**ORCUTT KEY SITE 3 PROJECT**

**PROPOSED FINAL SUBSEQUENT ENVIRONMENTAL  
IMPACT REPORT**

**REVISION LETTER #1**

**November 17, 2011**

**Figure 1 Revised Site Plan**

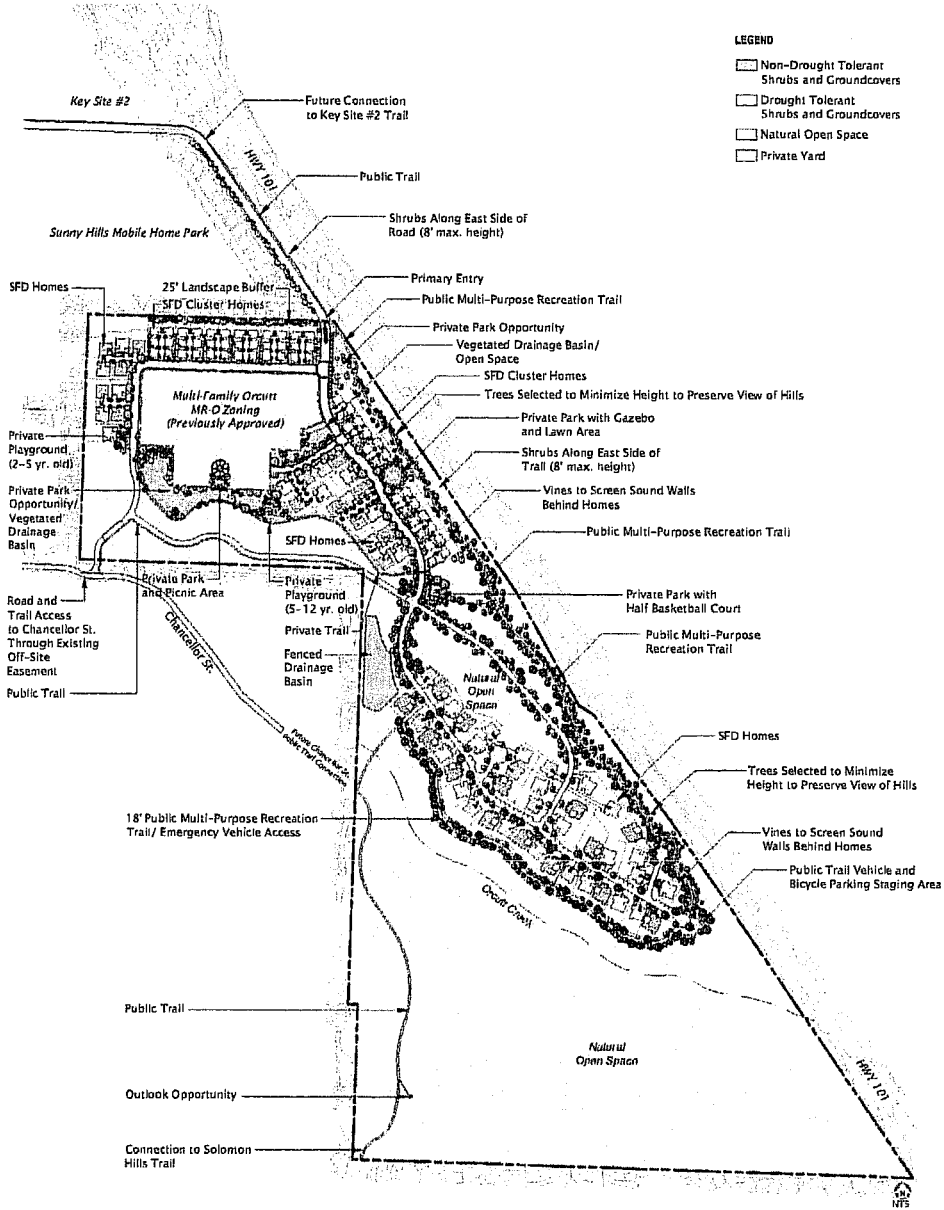
The proposed modifications to the Key Site 3 Project include a reduction in total units, an increase in setback from Highway 101, an increased buffer from the project boundary for residences along the northern and western portion of the Northern Mesa area, and elimination of the 11 estate lots previously proposed on the south side of Orcutt Creek. The number of single-family home cluster units within the Northern Mesa has been reduced from 99 to 85.

Within the Northern Mesa area, the row of 15 single-family home cluster units adjacent to the Highway 101 right-of-way (formerly Lots 50, 51, 56, 57, 62,63, 68, 69, 74, 75, 80, 81, 84, 85 and

86) have been eliminated, and one single-family cluster unit to the west of "Road A" has been added, for a net reduction of 14 units. Furthermore, the number of single-family homes within the Central Plain area has been reduced from 46 to 40. Within the Central Plain area, six homes near the southern portion of this development area have been eliminated, and minor site plan changes were made to provide a 125-foot minimum setback from the edge of the Highway 101 right-of-way. With the revised project's removal of the 11 estate lots in the South Hills, the associated span bridge over Orcutt Creek on the southeastern portion of the site has also been eliminated.

Elimination of the row of 15 units in the Northern Mesa area, adjacent to Highway 101, has increased the setback from property line to the closest unit from 94 feet to 125 feet. In addition, setbacks from the site's western property line for the single-family cluster units on Lots 5, 6, 9, and 10 have been increased from 25 feet to 50 feet. Similarly, the setbacks from the site's northern property line to the closest unit on Lots 15, 16, 21, 22, 27, 28, 33, 34, 39, 40, 45, and 46 have increased from 44 feet to 50 feet, which includes a 25-foot wide undeveloped buffer between the rear property lines of the residential units to the northern site boundary and 25-foot rear yard building setbacks.

Overall, these modifications would result in a reduction from 156 units as originally proposed to 125 units, or a total of 31 units, which includes a reduction of 14 units in the Northern Mesa, six units in the Central Plain, and 11 estate homes in the South Hills. The revised site plan is shown in Figure 1.
